Kleinfelder Midcoast Groundwater Study

Summary and Errata

Prepared by
Planning & Building Department
San Mateo County • California

Midcoast Groundwater Study Summary Attachment B: Errata

Midcoast Vacant Lots as of 2008

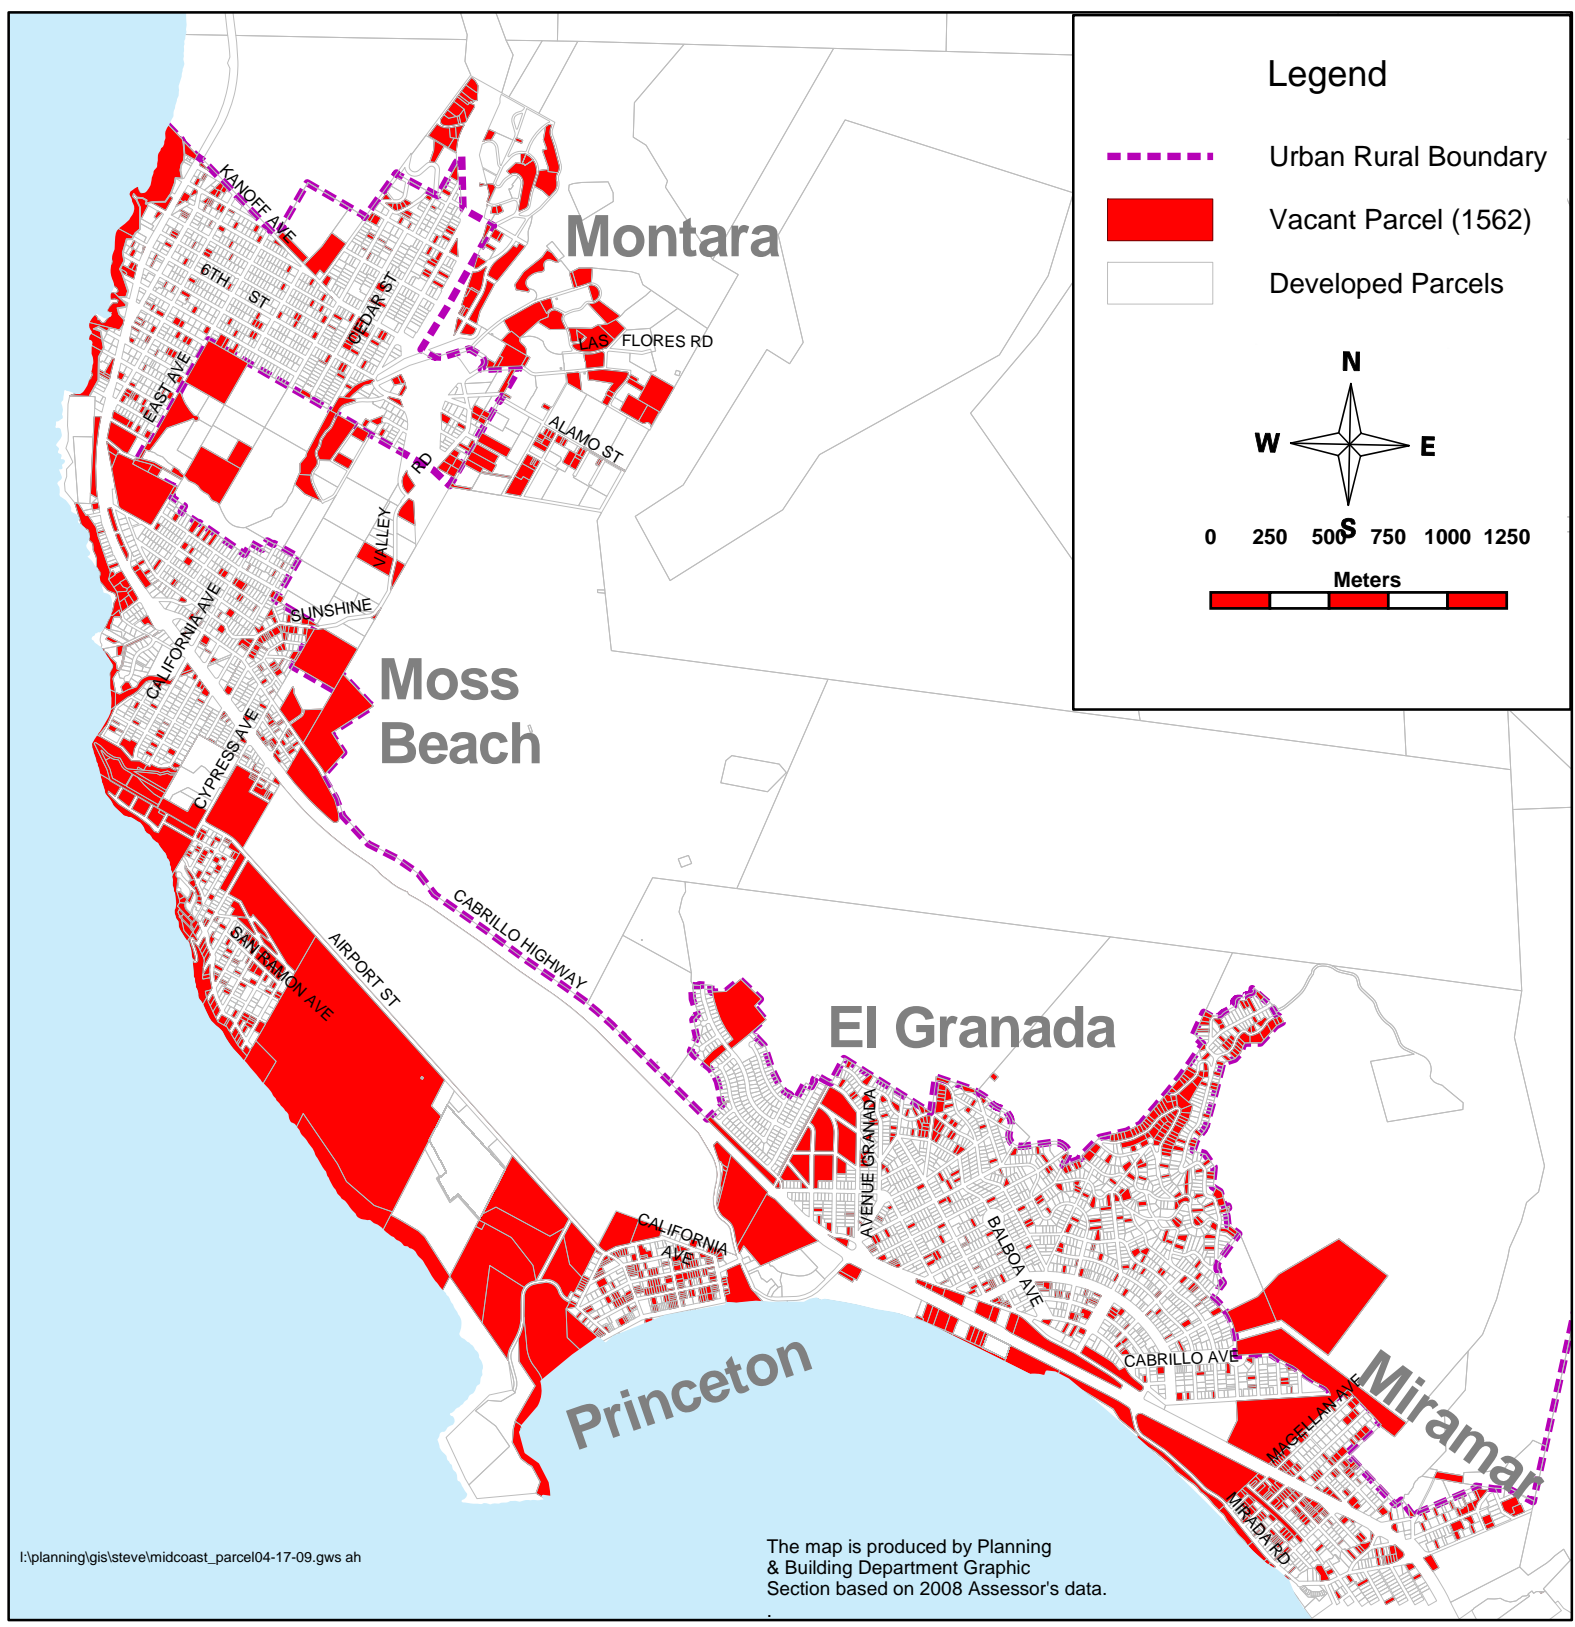
4. Plate 2 - delete “site” reference.
5. Plate 7 – replace Plate 7 contained in the report with the map of vacant parcels included as Attachment C.
